DOCUMENT CHANGE REQUEST

DCR number 509	Changes required for: General	Originator: S Jeffery - ESCC
Date: 2009/05/06	Date sent: 2009/05/06	Organisation: ESA/ESTEC
Status: IMPLEMENTED

Title:	Transistors Field-Effect N-Channel, based on types 2N4391/2N4392 and 2N4393		
Number:	5205/003	Issue:	2

ESCC Detail Specification No. 5205/003

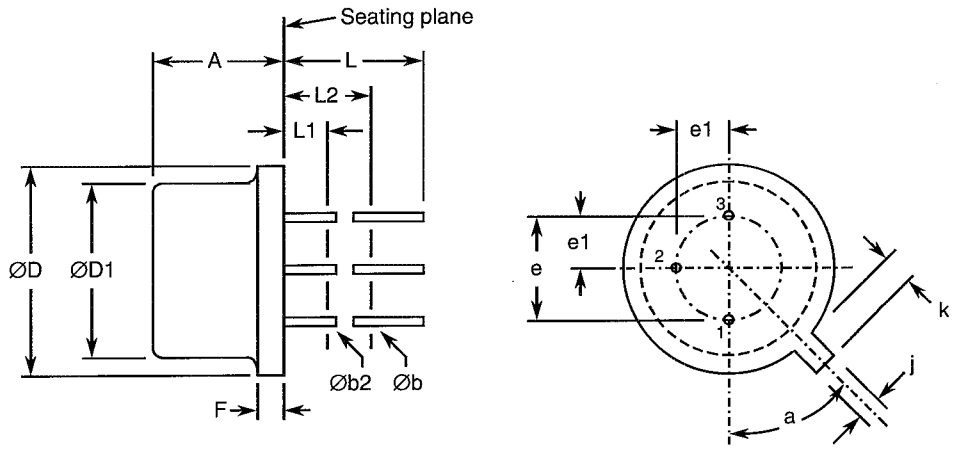
Update the Maximum Ratings table (see the attachment for details) so that this detail spec is clear, complete and the content and format is in-line with other detail specifications for similar Part Types.

Page 6: original Note 2 to Maximum Ratings, add ", and any handling,"between "testing" and "performed".

see attached

1. For $T_{amb} > +25°C$, derate linearly to 0W at +175°C.
1. For Variants with tin-lead plating or hot solder dip lead finish all testing performed at $T_{amb} > +125°C$ shall be carried out in a 100% inert atmosphere.
2. Duration 10 seconds maximum at a distance of not less than 1.5mm from the device body and the same lead shall not be resoldered until 3 minutes have elapsed.
